**RE: Submittal of Additional Information for December, 2000
Decommissioning Plan, COGEMA Mining, Inc.**

Additional Information Concerning the December 2000 Decommissioning Plan

**Decommissioning Plan
for
Irigaray and Christensen Ranch Projects
COGEMA Mining, Inc.**

Figure 3-1 Gamma Survey and Soil Sample Locations at Christensen Ranch Site

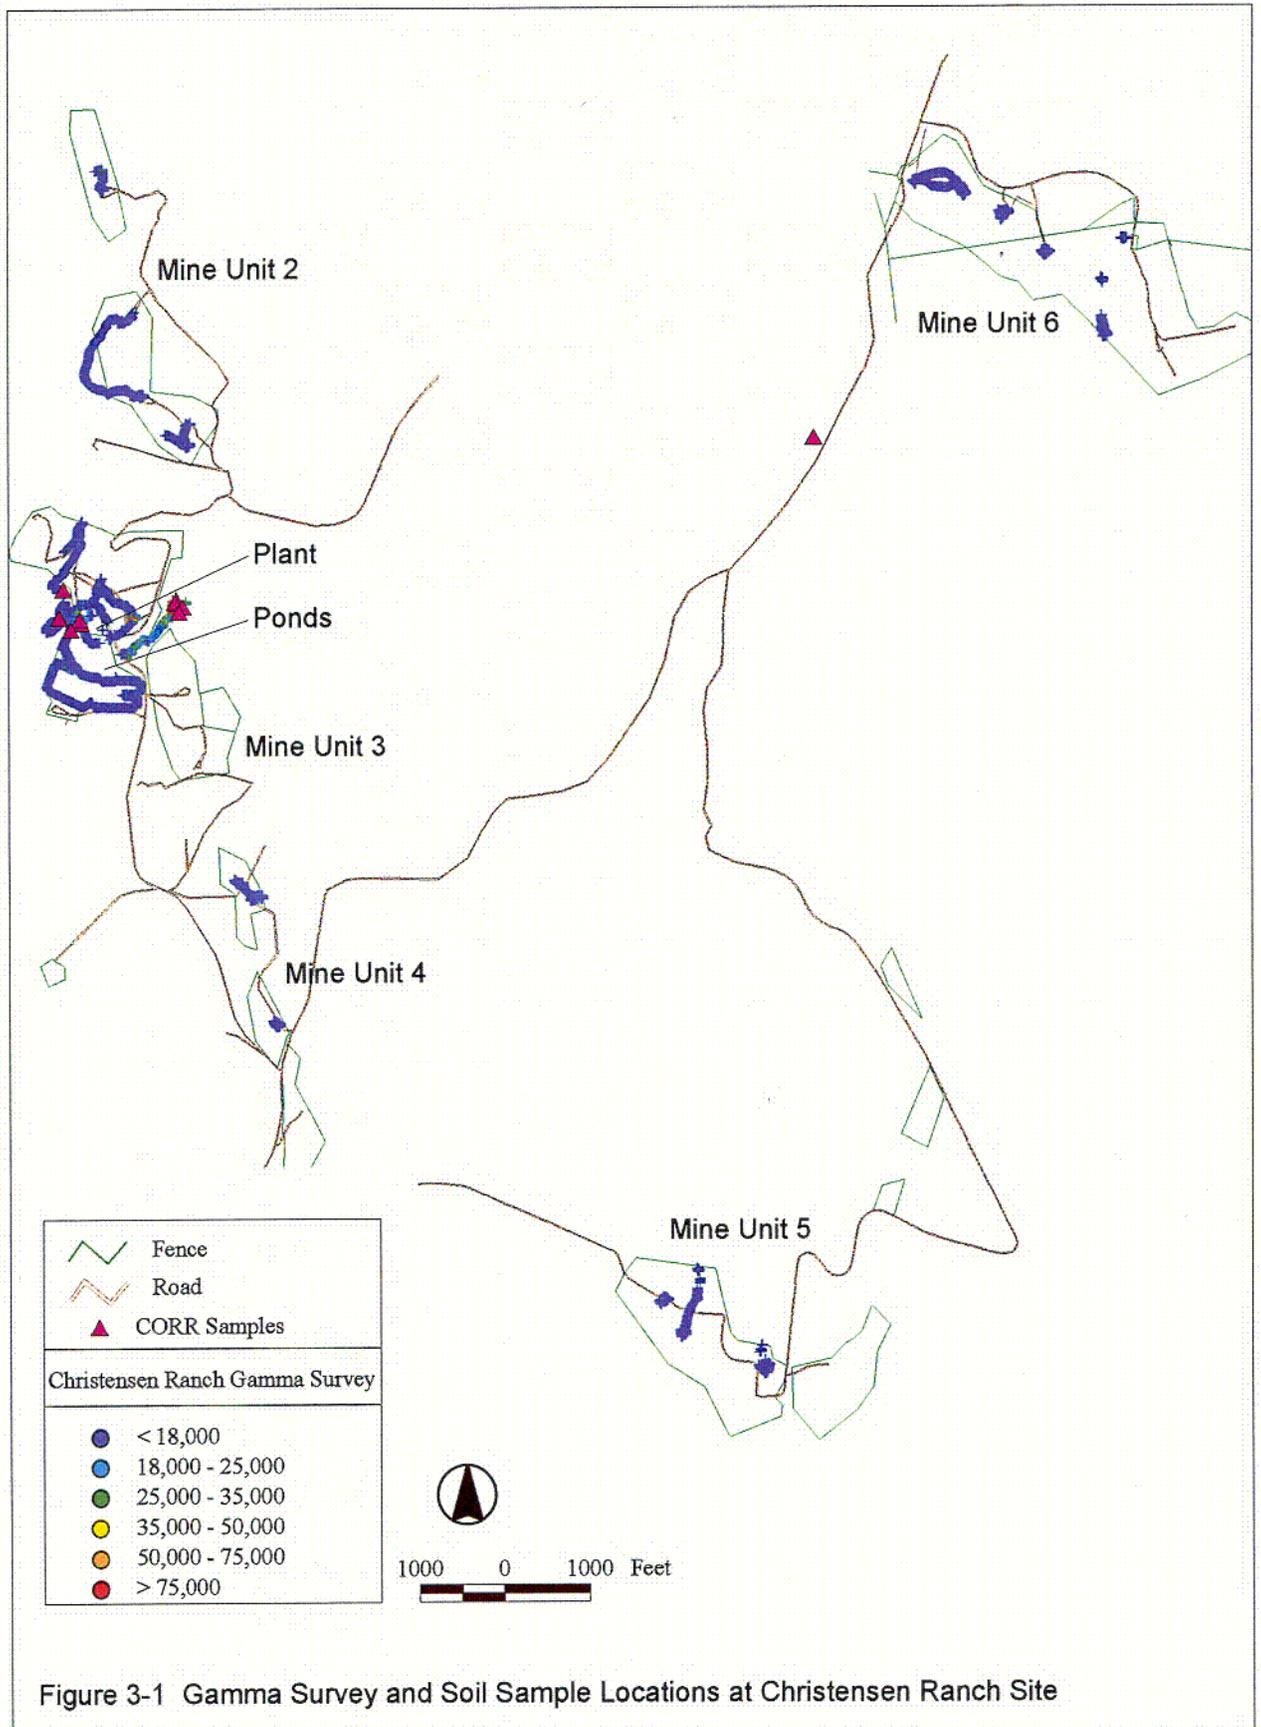
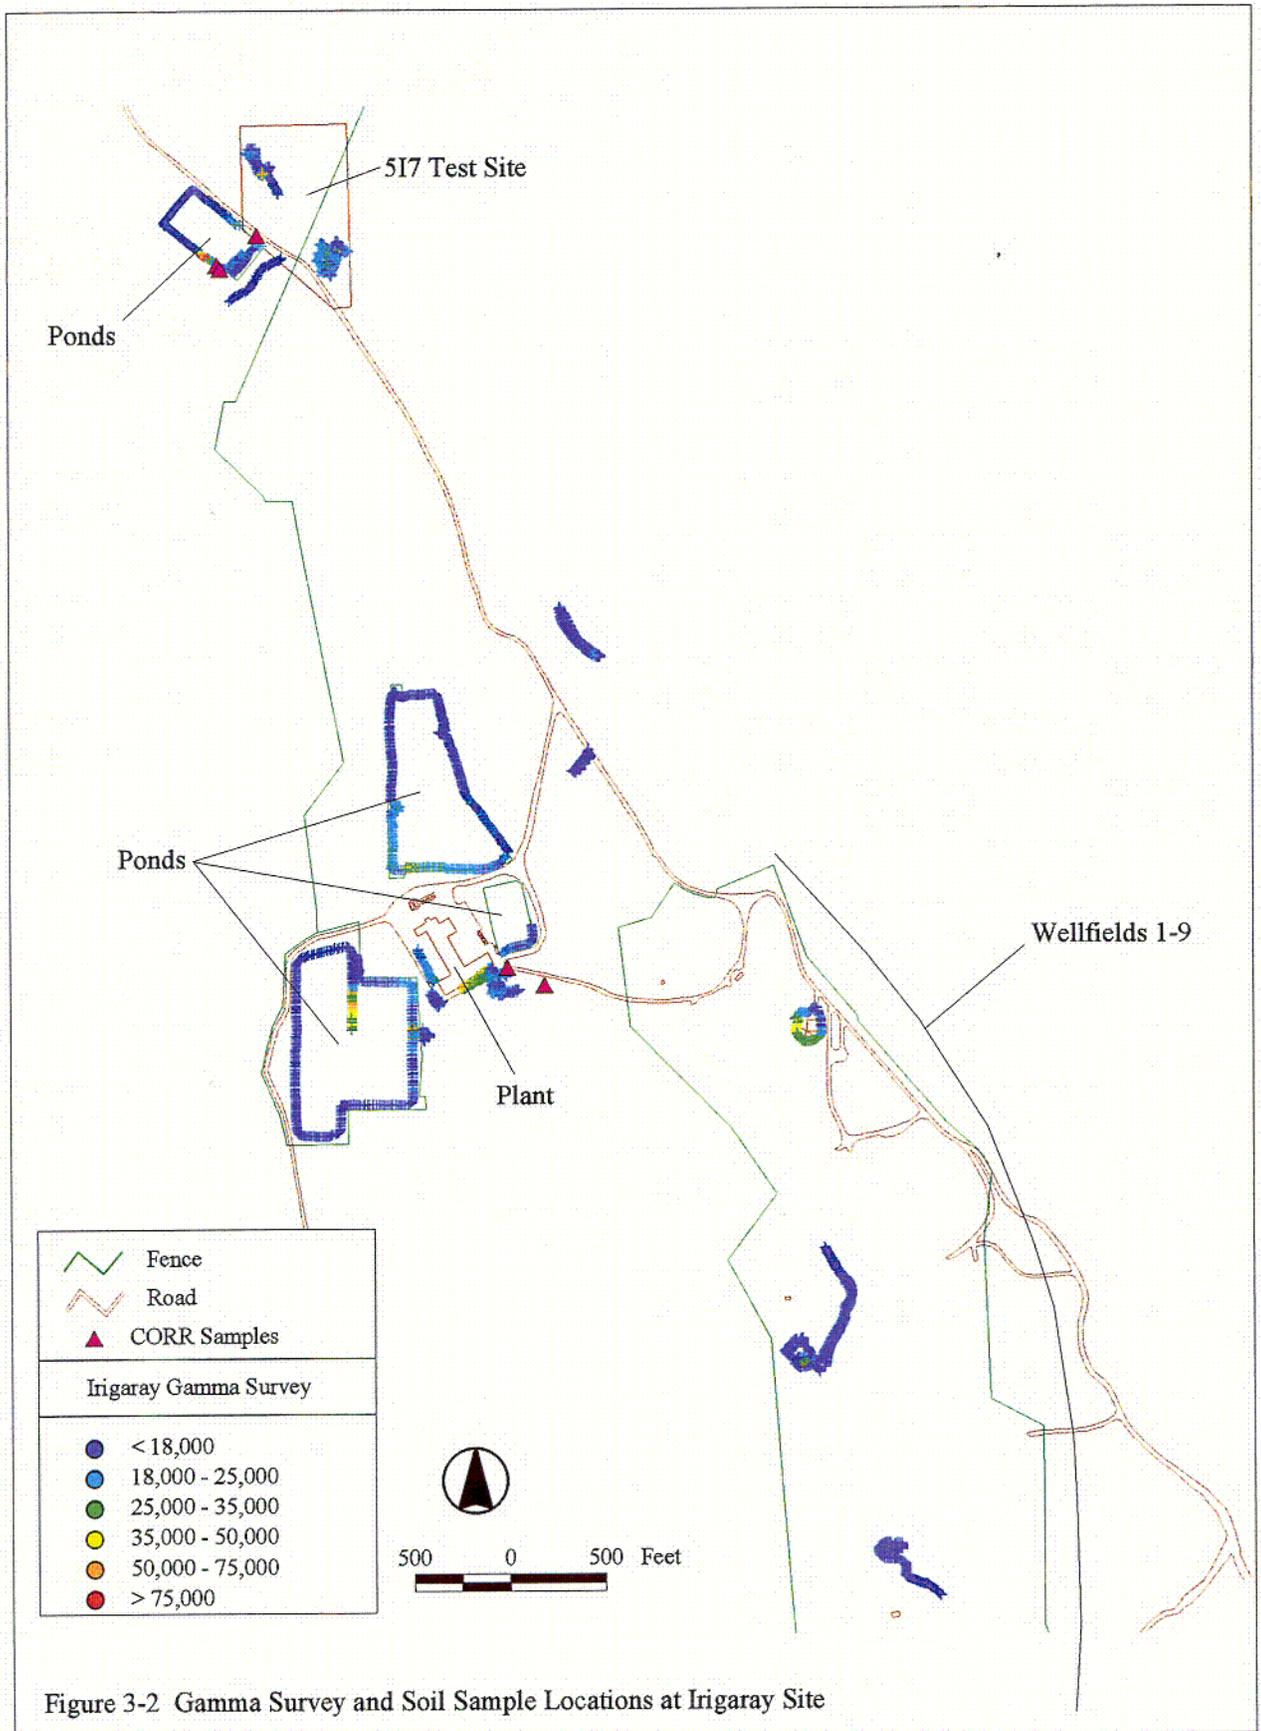
"Provide the estimated area of land (volume or size) that may require remediation. Also, clarify if the sample was obtained before the gamma reading was taken, as stated on page 36."

Section 3.2.2 (Gamma Survey and Soil Sample Data Results) was revised to indicate that the gamma readings were taken prior to obtaining soil samples.
